Monthly Specification Update

Intel® Server Boards S5000PSL and S5000XSL

Intel Order Number D62900-001

February, 2011

49. Recent Intel® Server RAID Adapters fail to activate RAID BIOS Console by Ctrl+G in S5000PSL and/or S5000XVN PCI slot 4

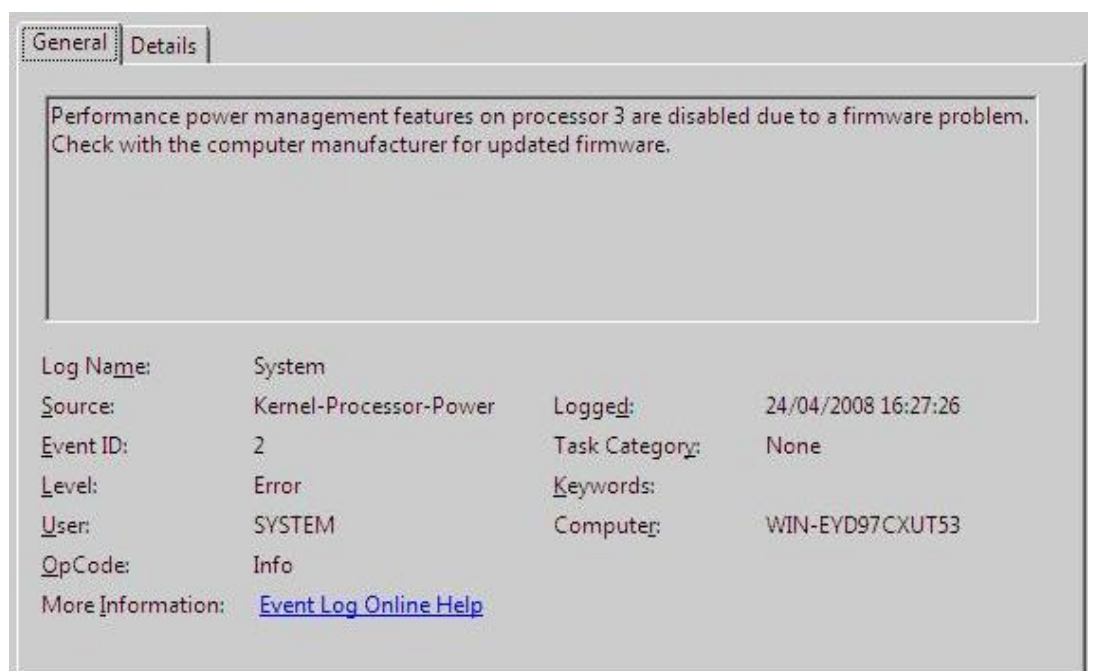
Problem Intel® RAID Controllers SRCSASJV, SRCSASRB, SRCSATAWB, SRCSASBB8I and SRCSASLS4I may fail to activate RAID BIOS Console by Ctrl+G after installed into PCI Slot 4 on the Intel® Server Board S5000PSL or Intel® Workstation Board S5000XVN Implication Fail to configure RAID in PCI slot 4.

Status This erratum was fixed with BIOS R0094
